Council Assessment Panel Minutes

16 December 2024

5.1 DEVELOPMENT NUMBER – ID 24026013 – STEVIE-ANN SPENCER –
16 FULLARTON ROAD NORWOOD

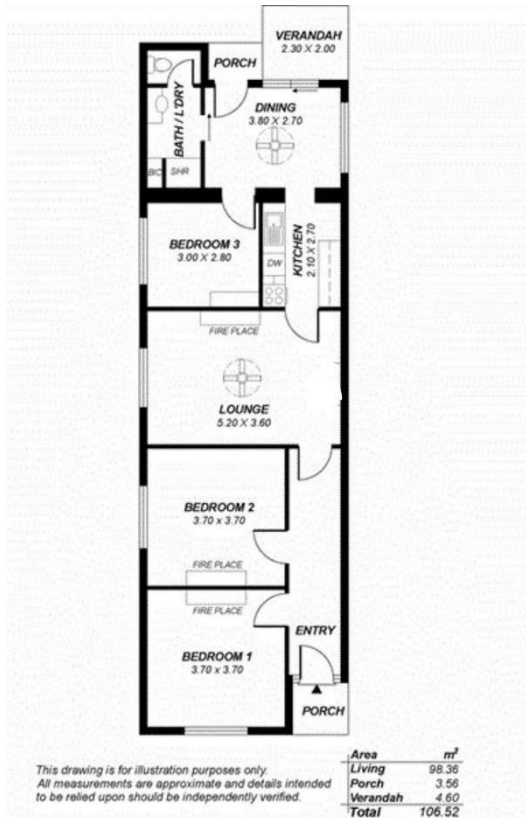
<p>PO 3.1 Overshadowing of habitable room windows of adjacent residential land uses in:</p> <ul style="list-style-type: none"> a) A neighbourhood-type zone is minimised to maintain direct winter sunlight b) Other zones is managed to enable access to direct winter sunlight 	<p>DTS/DPF 3.1 North-facing windows of habitable rooms of adjacent residential land uses in a neighbourhood-type zone receive at least 3 hours of direct sunlight between 9.00am and 3.00pm on 21 June.</p>
<p>PO 3.2 Overshadowing of the primary area of private open space or communal open space of adjacent residential land uses in:</p> <ul style="list-style-type: none"> a) A neighbourhood-type zone is minimised to maintain direct winter sunlight b) Other zones is managed to enable access to direct winter sunlight 	<p>DTS/DPF 3.2 Development maintains 2 hours of direct sunlight between 9.00 am and 3.00 pm on 21 June to adjacent residential land uses in a neighbourhood-type zone in accordance with the following:</p> <ul style="list-style-type: none"> a) for ground level private open space, the smaller of the following: <ul style="list-style-type: none"> i) half the existing ground level open space or ii) 35m² of the existing ground level open space (with at least one of the area's dimensions measuring 2.5m) b) for ground level communal open space, at least half of the existing ground level open space.

PO 3.3 of this module relates to overshadowing of solar panels, however, of the dwellings to the south of the site, only 1 Rosemont Street has solar panels, and given that these are on an upper storey, they would not be affected by the proposed development.

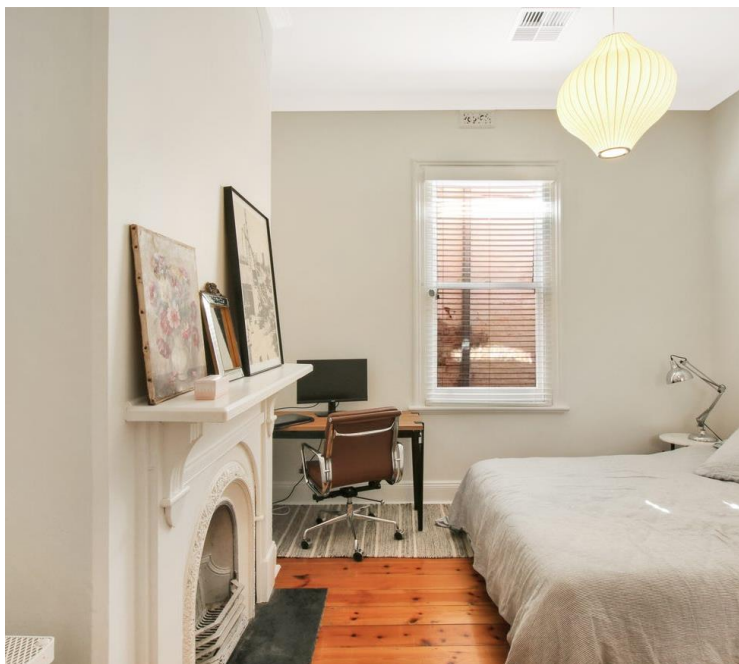
Regarding overshadowing of windows, 116 Sydenham Road has three windows to habitable rooms along the northern side wall as shown in the floor plan below sourced from realestate.com.au:

The owner of 116 has noted that they presently receive northern light through the north facing windows, and has supplied photos which show this in their representation (which are also available on realestate.com.au). There is a 1m setback along this northern side.

Considering the shadow diagrams provided, these windows would be unlikely to receive any direct light between 9am and 3pm on 21 June, either pre or post development, so consideration of the DPF is somewhat redundant in this case. The windows would, however, receive sun in other seasons where the sun's angle would be higher.
